ADDENDUM NO. 2

**Coventry Township
NEW FIELD HOUSE
Logan Field
2701 North turkeyfoot Road
Akron, Ohio 44319**

**Prepared by
Four Points Architectural Services, Inc.**

April 29, 2024

E1.1
21-025

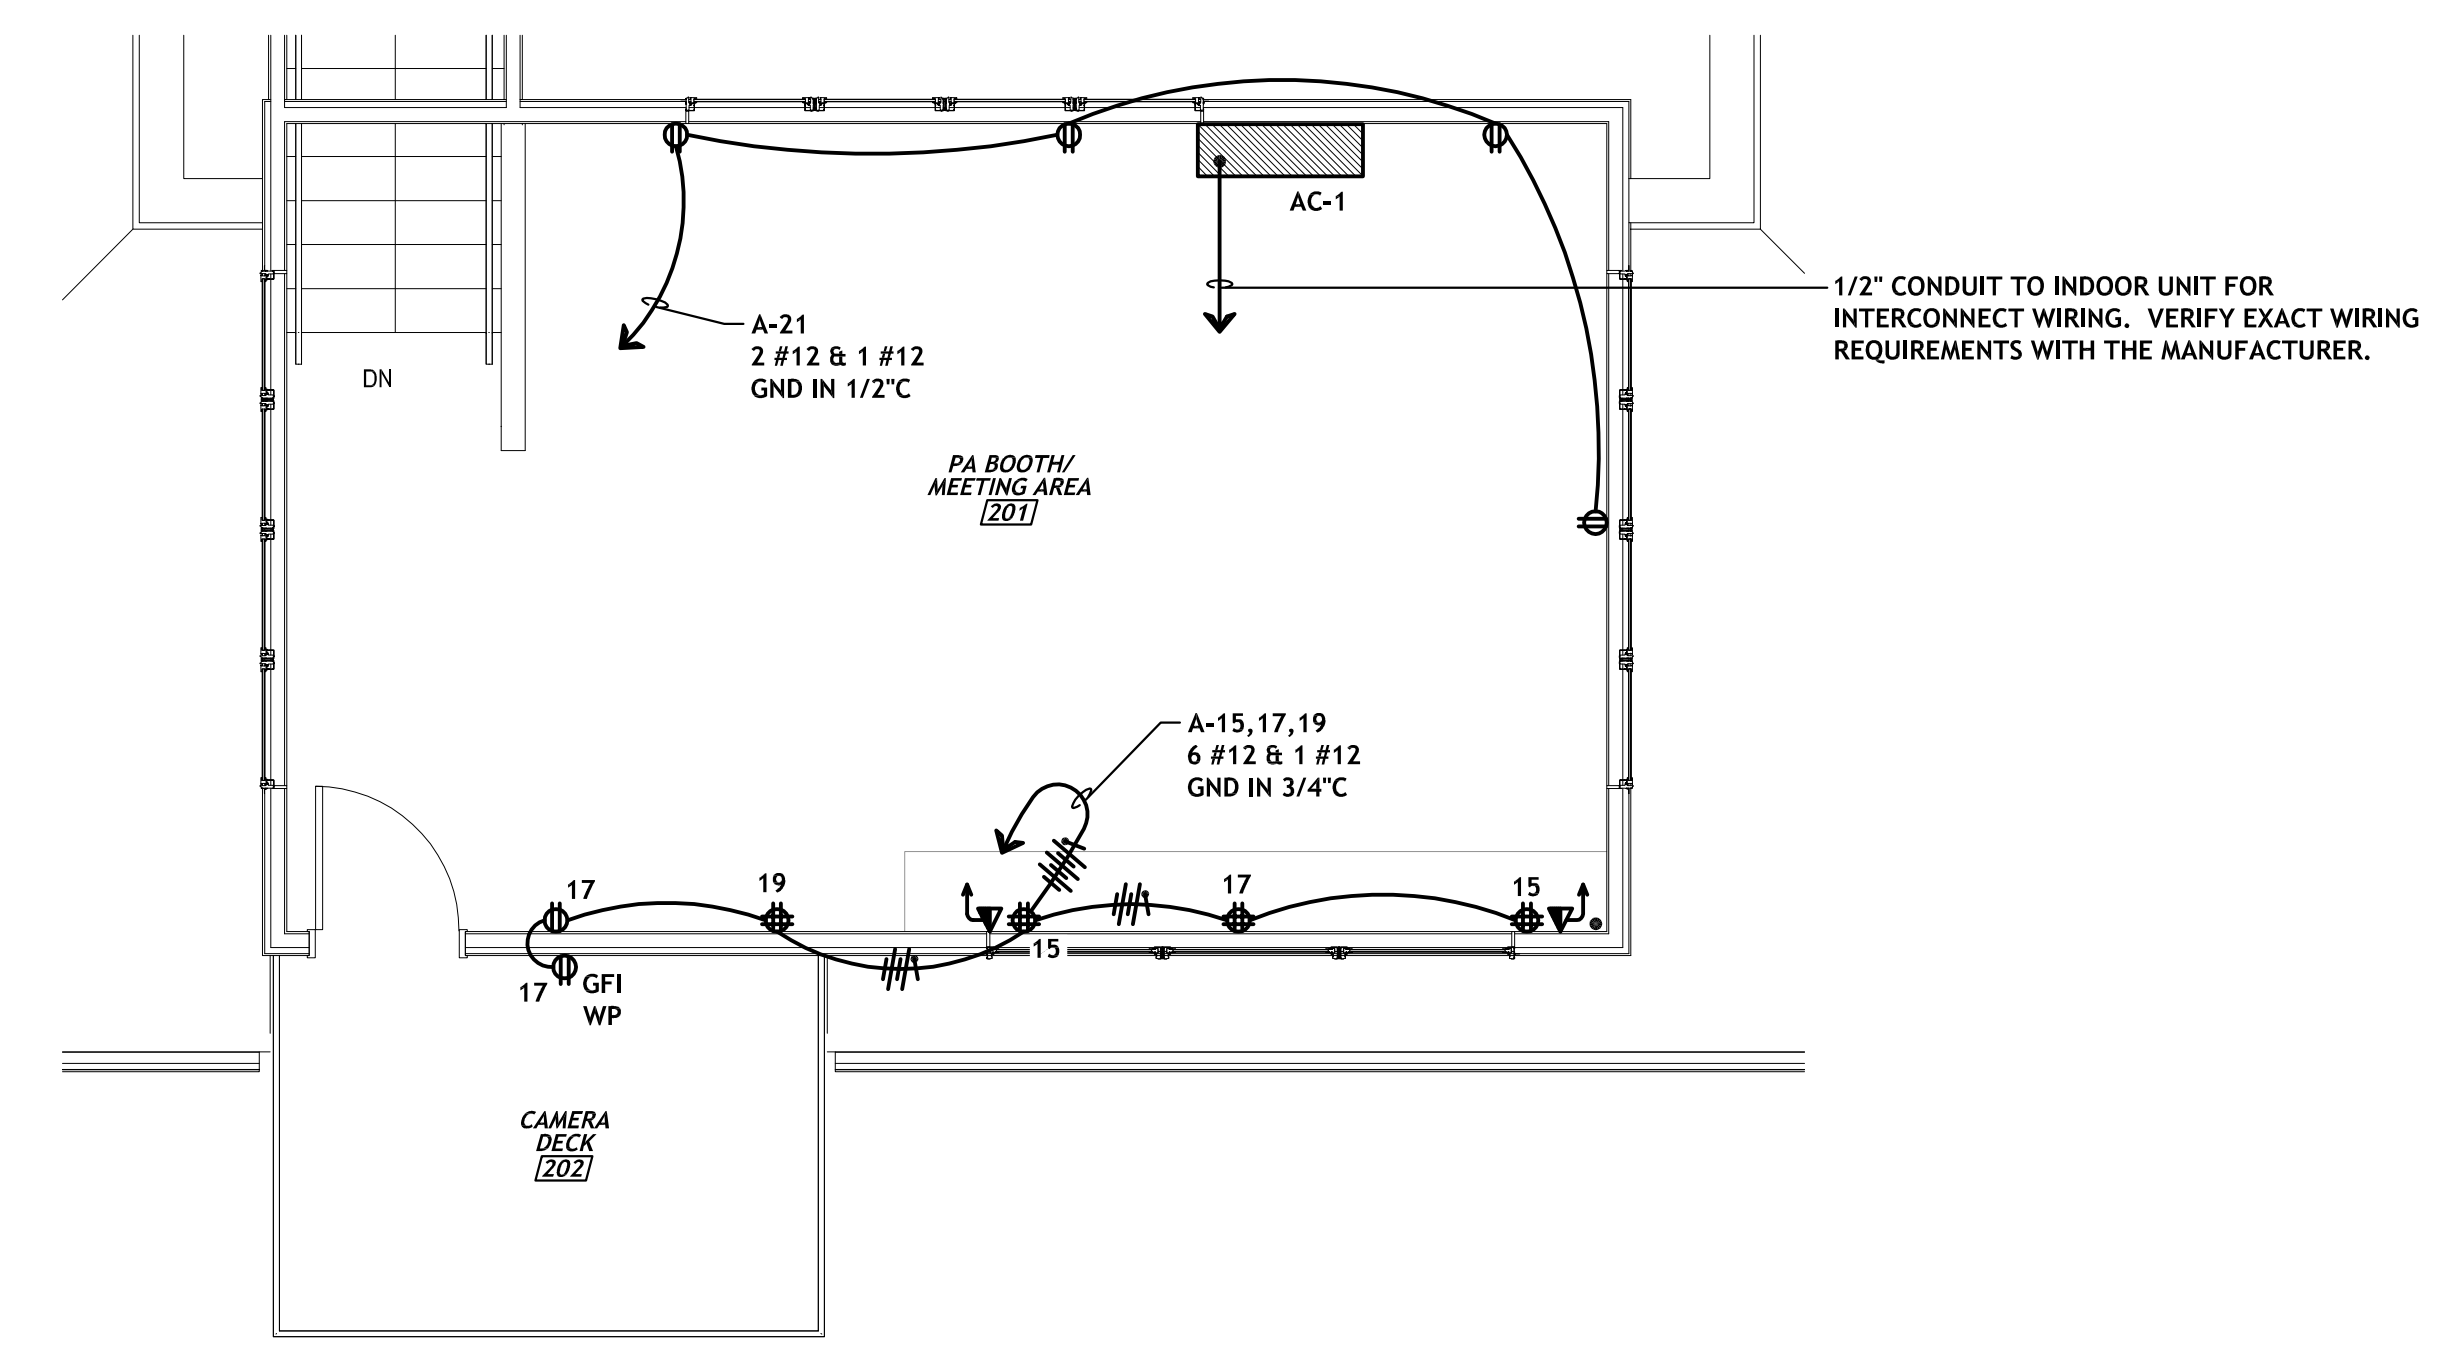
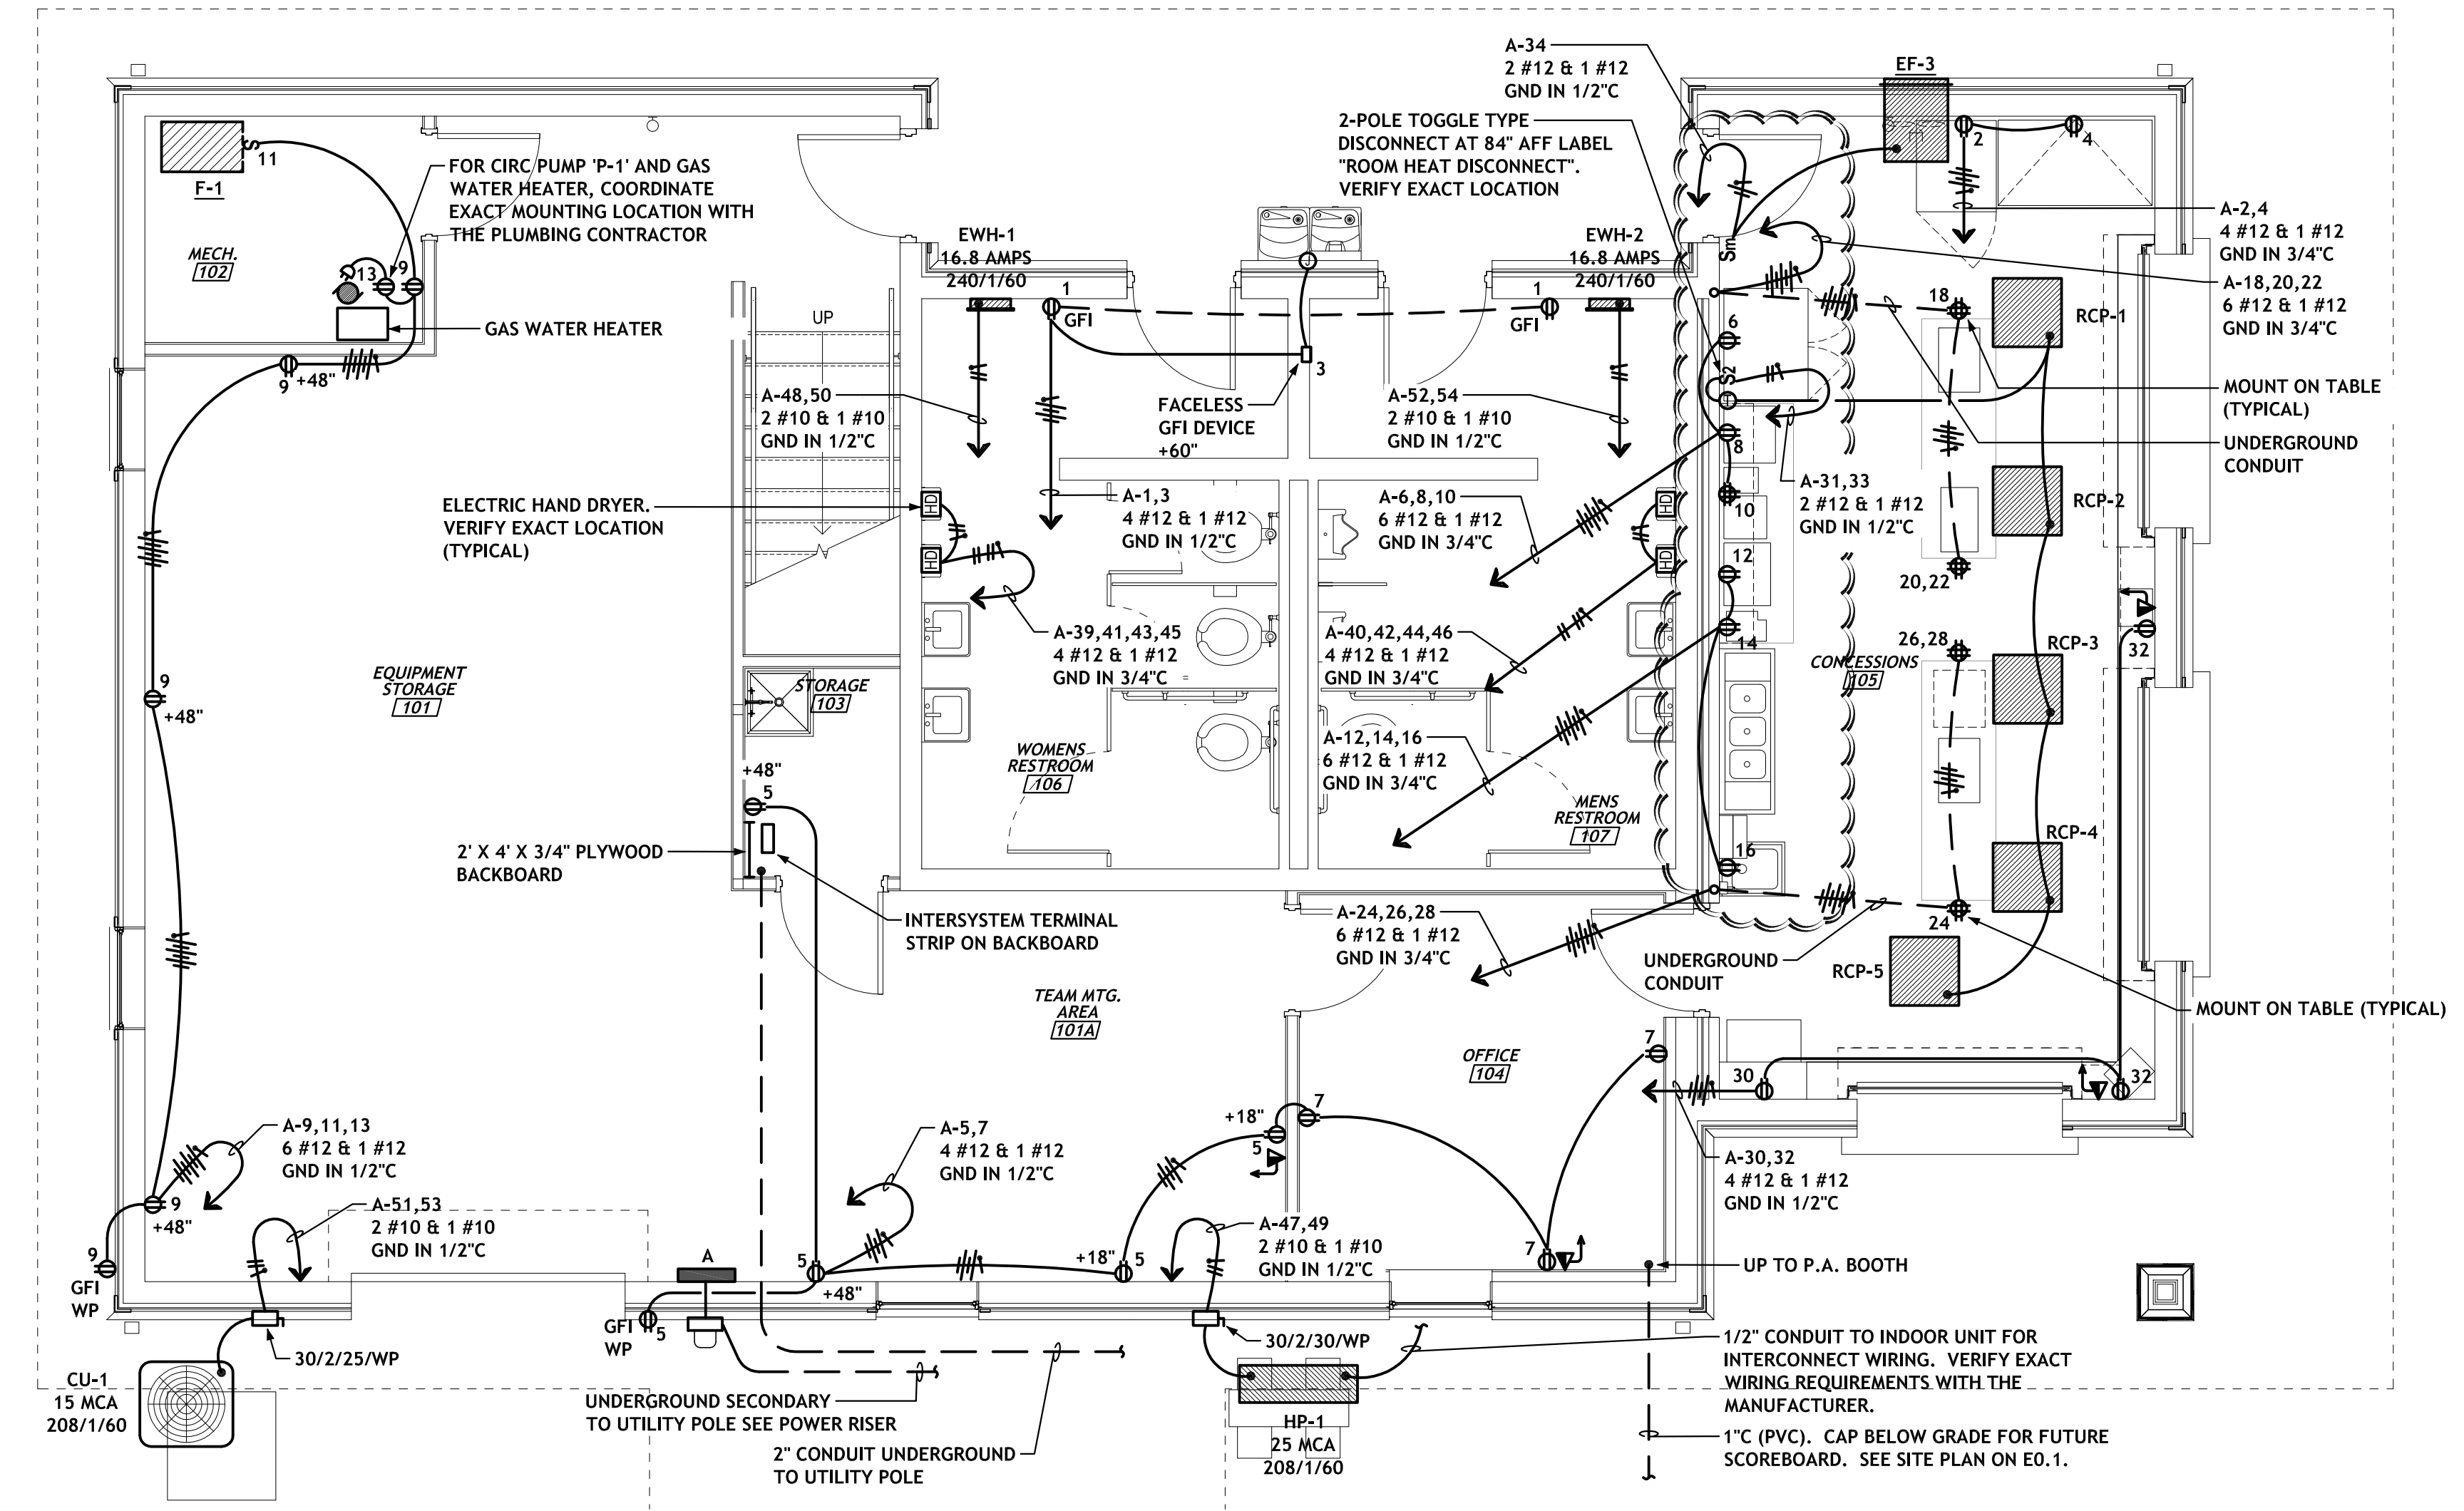
13. Sheet E1.1 – Power / Systems Floor Plans:

- a. The outlet layout in the concessions area has been revised to accommodate the new equipment plan.
